Municipal Address: 600 and 650 Highway 7 East and 9005 Leslie Street

Subject Lands: Part of Block 1, Plan 65M-2287

Landowner: Parkway Hotels & Convention Centre Inc. (650 Hwy 7 East Inc., 9005 Leslie St Inc.)

Figure 15: Lower Ground Service and Access Diagram

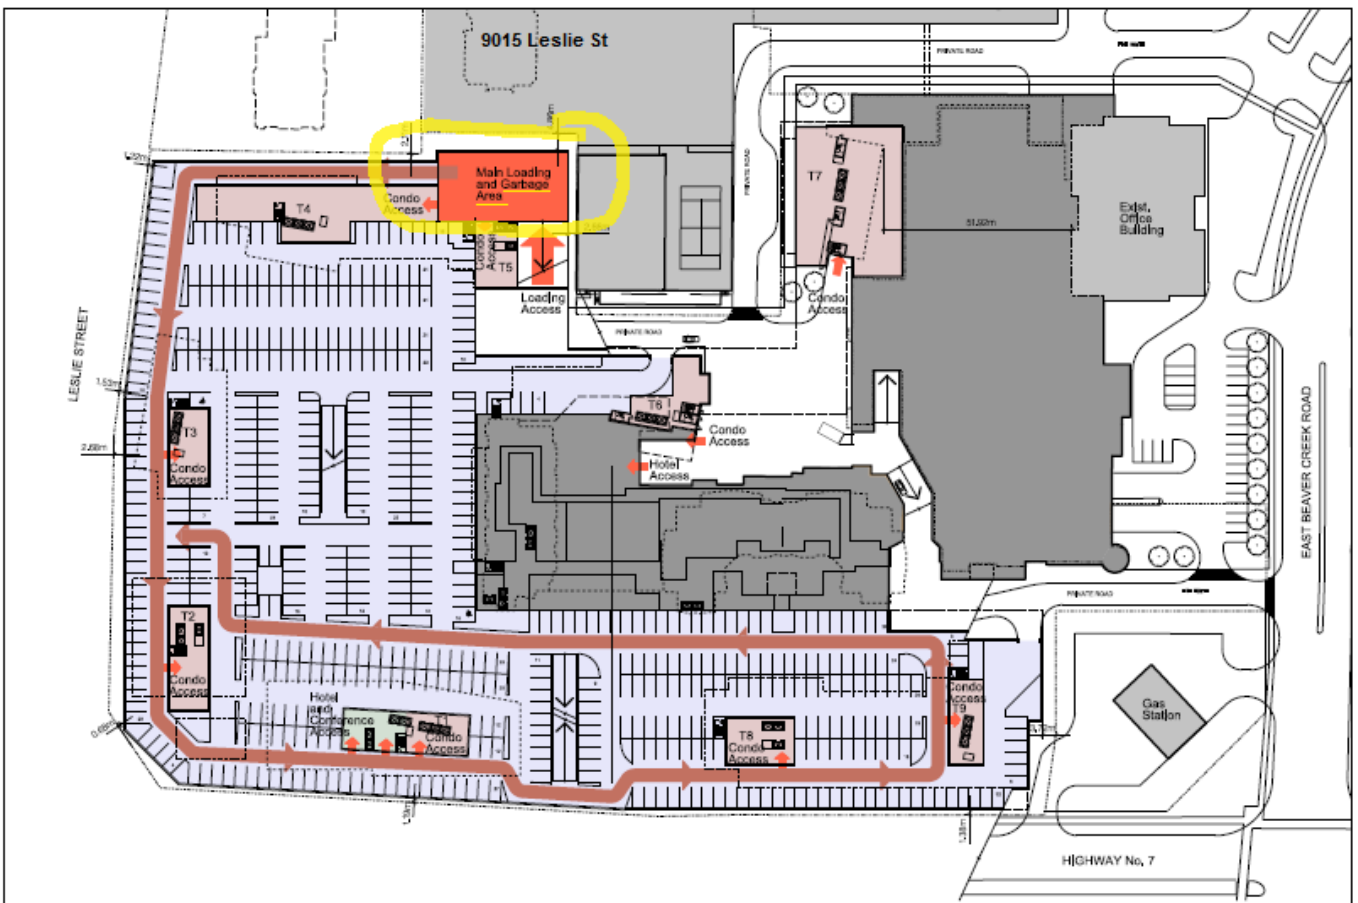
4. According to the Master Concept Plan, page 30 (inserted below), there will be only **one large garbage area consolidating garbage from 9 towers**. The width span of this garbage & main loading area appears to be over 30m and is wider than the south end of the 9015-condominium building. Despite being on the lower ground floor level, the ventilated **odour of decaying garbage** (between City garbage pickups) from the 9 towers (3460 dwelling units) **concentrated in one area** will be extremely unbearable and present physiological and psychological stress to 9015/9017 residents, especially to those residing on the southside of the 9015-condominium building only 17m away.

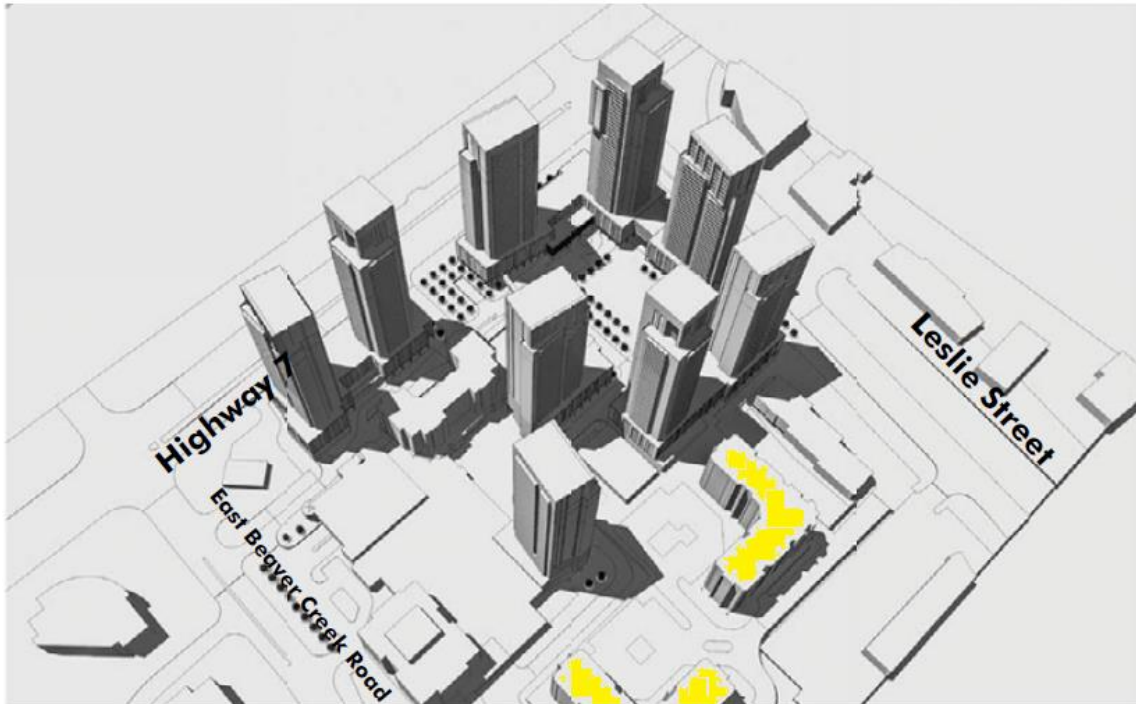
For example, on pages 10-32, Eastbound traffic data on Highway 7 between Leslie St & Commerce Valley Dr. (East Beaver Creek Road) are as follows:

<u>Year</u>	<u>(PM)</u>	<u>AM</u>
2022	(1625)	1524
2028	(1689)	1584 = increase of (64) 60 vehicles in 6 years (full build-out)
2033	(1746)	1637 = increase of (121) 113 vehicles in 11 years
2038	(1804)	1692 = increase of (179) 168 vehicles in 16 years

An **increase of (64-179) vehicles in the PM** rush hours and **60-168 vehicles in the AM** rush hours along Highway 7 between Leslie St & Commerce Valley Dr. (East Beaver Creek Road) within the **next 16 years** appears grossly understated and misleading given the scale of some of the development projects mentioned in c) above. Assuming only 5% of the 10,000 Downtown Markham residents travel through this intersection during rush hours daily, that alone is already an addition of 500 vehicles on Highway 7 between Leslie St & Commerce Valley Dr. (East Beaver Creek Road).
